POLK COUNTY PLANNING COMMISSION
OCTOBER 19, 2021, 6:00 P.M.
POLK COUNTY COURTHOUSE
FIRST FLOOR CONFERENCE ROOM
850 MAIN STREET
DALLAS, OREGON

RE: Alteration to a Historic Building; Polk County Planning File LUD 21-11.

**Polk County Community Development Department
Planning Division Staff Report**

APPLICATION FOR: The Polk County Planning Commission will hold a public hearing to consider exterior alterations to a historic structure, the Phillips House, which is included on the Polk County Historic Resource Inventory, the Statewide Inventory, and the National Historic Register. The applicant is requesting to alter the existing front porch, wood siding, wood windows, exterior lighting, foundation, and roof of the Phillips House. In addition, the applicant is proposing to remove the existing single-story rear addition and replace it with a two-story rear addition. The subject property is located in the Exclusive Farm Use (EFU) Zoning District and is an approximately 2.3 acre parcel that was created as a nonfarm parcel for historic property.

Figure 1: Existing windows on the front of the Phillips House.

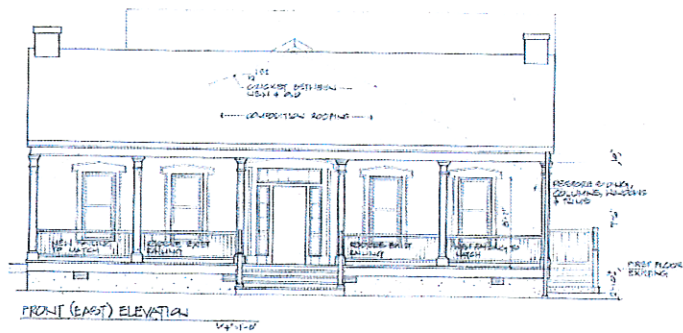
Based on the photographs and plans provided by the applicant, the existing windows on the east side of the dwelling (front) are composed of a single large pane of glass and would remain a single large pane of glass. However, the National Register suggests that this was not original but existed at the time the property was included in the Register.

Figure 7: Proposed windows for the south side of the new addition.

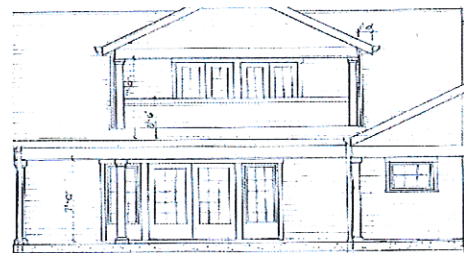
Based on photographs provided by the applicant, staff understands that the existing windows on the rear of the single-story addition have four lights over four (see Figures 5 and 6). Based on the plans submitted, the proposed windows on the rear two-story addition, the pane orientation would vary between three lights over three and the other windows associated with the French doors don't appear to be double hung and contain both fourteen and eight lights on a single pane. (see Figure 7).

Figure 9: Proposed windows for the north side of the new addition

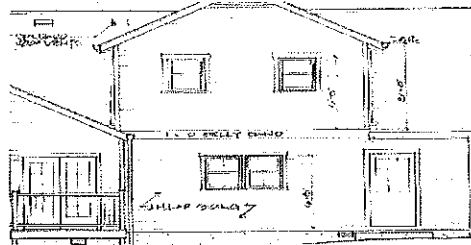
Based on photographs provided by the applicant, the window pane orientation on the north side of the existing addition is unclear (see Figure 8). Based on the plans submitted by the applicant, the proposed pane orientation of the north side of the new addition would vary between single panes and two lights over two (see Figure 9).

Figure 11: Proposed windows on the south side of the proposed addition.

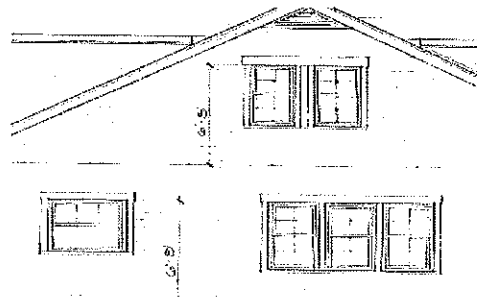
Based on the photographs provided by the applicant, it is unclear what the window pane orientation is for the south side of the existing addition (see Figure 10). Based on the plans submitted by the applicant, the proposed window pane orientation of the south side of the rear addition would be three lights over three and four lights over four (see Figure 11). The remainder of the opening on this side of the addition would be French doors, which is discussed in greater detail in subsection F below.

Figure 12: Existing east facing side (front porch) of the primary dwelling.

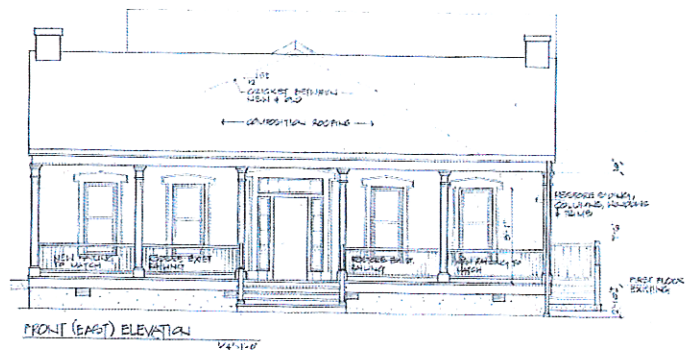
The east facing side (front porch) has approximately 175.5 square feet of fenestrations and 454.7 square feet of solid space (see Figure 12). The proposed east facing side (front porch) has approximately 175.5 square feet of fenestrations and 454.7 square feet of solid space (see Figure 13).

The existing east facing side (front porch) of the Phillips House has a centered Federalist entry with two windows on either side that are spaced approximately 3 feet and 3 inches apart to provide a symmetrical appearance. The proposed east facing side (front porch) of the Phillips House would continue to have a Federalist entry with two windows on either side that vary in spacing between approximately 4 feet to 3 feet but would retain the symmetrical appearance.

Staff finds that based on the plans provided by the applicant, the symmetrical appearance of the east facing side (front porch) of the Phillips House would be retained. Additionally, based on staff calculation of square footage for fenestrations and solid space, the void space to solid space of the east facing side would substantially remain the same and would be visually compatible with the traditional architectural character of the historic building to the extent possible. Therefore, staff finds the east facing side complies with this criterion.

Figure 15: Proposed north facing side of the new addition.

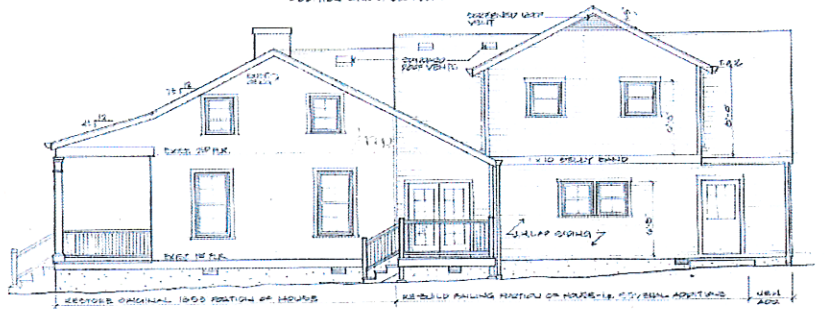
The north facing side of the proposed addition has approximately 113.5 square feet of fenestrations and approximately 468.2 square feet of solid space. (see Figure 15). The north side of the proposed addition would contain approximately 24.2% of its total area as fenestrations.

Staff finds that since the centered windows on the lower story and the single-man door would not be consistent with the traditional placement and proportions found on the historic primary dwelling, the application does not demonstrate that the north side of the proposed addition would not be visually compatible to the extent possible with the Phillips House.

Figure 19: Proposed west facing side of the new addition.

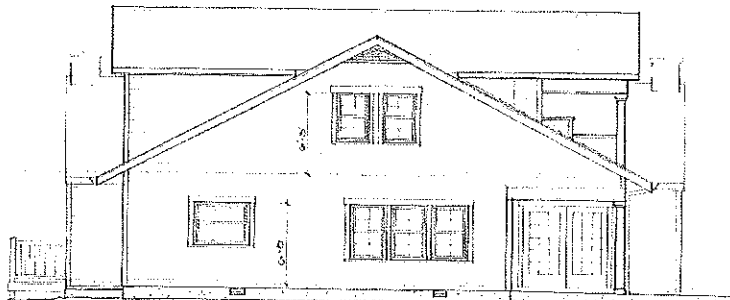
The rear (west facing side) of the proposed addition has approximately 150.3 square feet of fenestrations and approximately 385.1 square feet of solid space (see Figure 19).

The rear of the dwelling is not visible from the public right of way. Nevertheless, staff finds that the scale and proportion of the west facing side would not be visually compatible with the traditional architecture used on the historic landmark because the proposed upper window proportions do not match how the primary dwelling's windows are proportioned. Additionally, the proposed fenestration locations would not result in a symmetrical appearance with the lower four windows broken out into a bank of three windows and one single window. The rear of the proposed addition would not retain the characteristic of the Classical Revival style because the proposed fenestration locations are not symmetrical and they do not match the historic proportions (see Figure 19). Therefore, staff finds that the proposed addition would not be visually compatible to the extent possible with the traditional architectural character of the Phillips House.

Another component of the proposed addition are the two different gable roofs. As depicted on Figure 19, the proposed addition would have two gable roofs with one gable oriented in an east to west direction and another gable oriented in a north to south direction. This would result in each side of the proposed addition presenting a gable end, which is not currently the case for the primary
